This manuscript aims to study the effects of beach morphological changes, hydrodynamic boundary conditions, and hydrogeologic properties on flow regimes, salt distribution, and the potential for mixing controlled chemical reactions in high-energy beach aquifers. The authors achieve this objective by building 2-D transient density-driven groundwater flow and transport numerical models that systematically explore boundary conditions and hydrogeological parameters in a changing beach morphology setting. The authors then conclude that changing beach morphology causes the migration of infiltration and exfiltration locations along the beach transect, leading to moving flow and salt patterns in the subsurface and enhancing mixing-controlled reactions.

Dear Reviewer #1 we appreciate your time and thank you for thoroughly reading and reviewing our manuscript. We appreciate the overall positive evaluation. Your comments are very valuable and improve the quality of our manuscript. We have responded to your comments point by point as indicated by Author Comments (AC) in blue, planned changes to the manuscript are indicated by "speech mark".

Update to Figure 5:

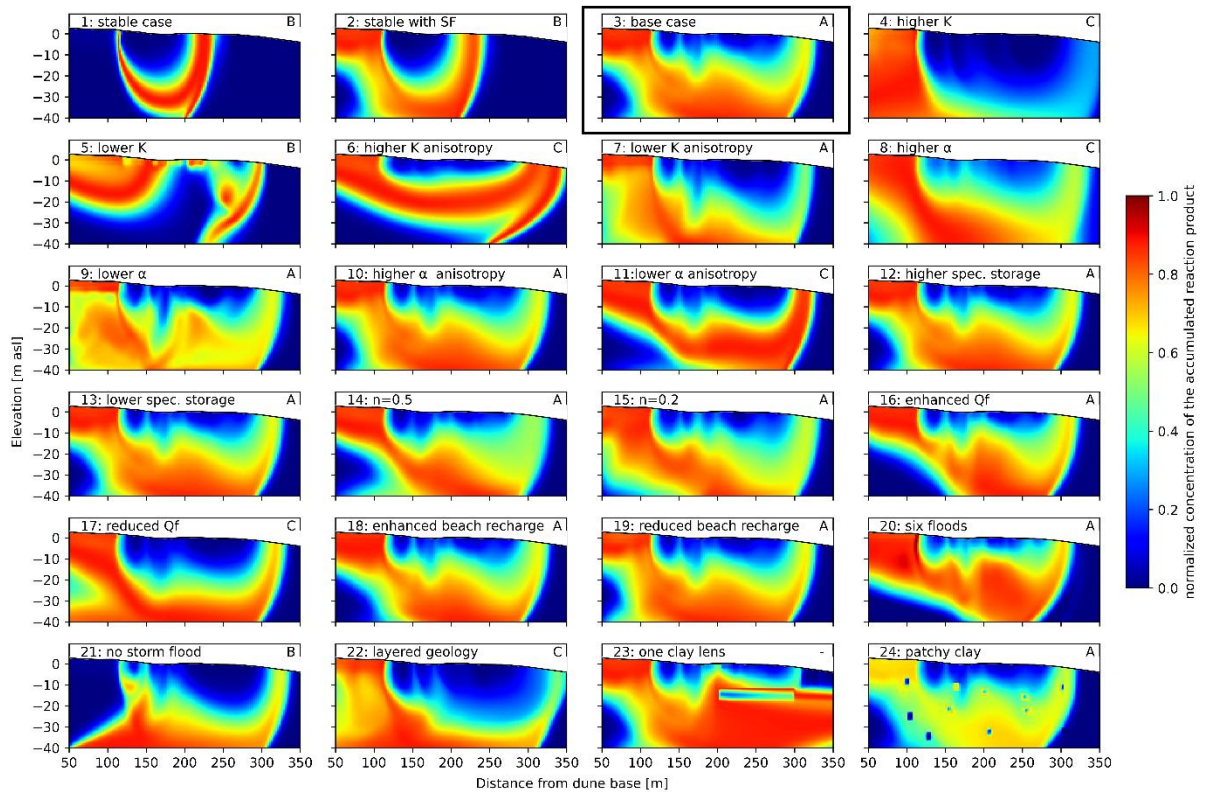
2. Regarding mixing-controlled reactions, the authors used the initial salinity patterns for the Rf and Rs concentration patterns. This modeling choice could create misleading mixing patterns because these chemical constituents were assumed conservative, and the model needs to stabilize first. So, did the authors consider warming up the model before setting the initial concentration patterns?

AC: The reviewer is right that the initial distribution of Rf and Rs could have had an effect on the final patterns of their mixing product (Mp). In order to resolve this issue, we have now subtracted the accumulated mixing concentration after 10a (when the initial concentrations of TDS did not influenced final salinity patterns any longer) from the final (20a) simulation concentration. The general mixing patterns look very similar to the previous results, as presented in the new Figure 5 (see below). However, slight changes in normalized concentrations are visible (Fig. 5). Therefore, we decided to follow the reviewers recommendations and update Figure 5 and also re-calculate the cluster analysis (Fig. 6) which also shows slight differences. Moreover, we will modify the corresponding text about the cluster analysis. However, the overall changes were only minor and the general picture and conclusion driven are still valid.

Update to Figure 6:

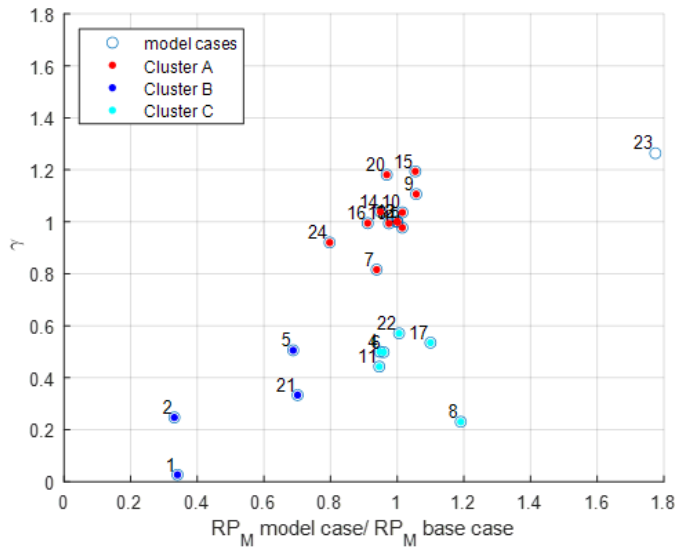
14. I consider the clustering analysis a neat exercise for examining similar models. However, switching between Figure 6 and Figures 3 through 5 can be cumbersome. I recommend adding boxes around the subplots in Figures 3 to 5 that represent the colors of the clusters; that way, it is easier for the reader to visualize which models are clustered together.

The cluster analysis in the result section will be modified to:

AC: We understand the need for a better recognition of clusters in the Figures 3, 4 and 5. Instead of adding colored boxes we will add the cluster groups name "A, B, C", in the upper right corner for each subfigure in Figures 3 to 5. These cluster groups are also referred to in Table 1. We will extend the Figure captions respectively by
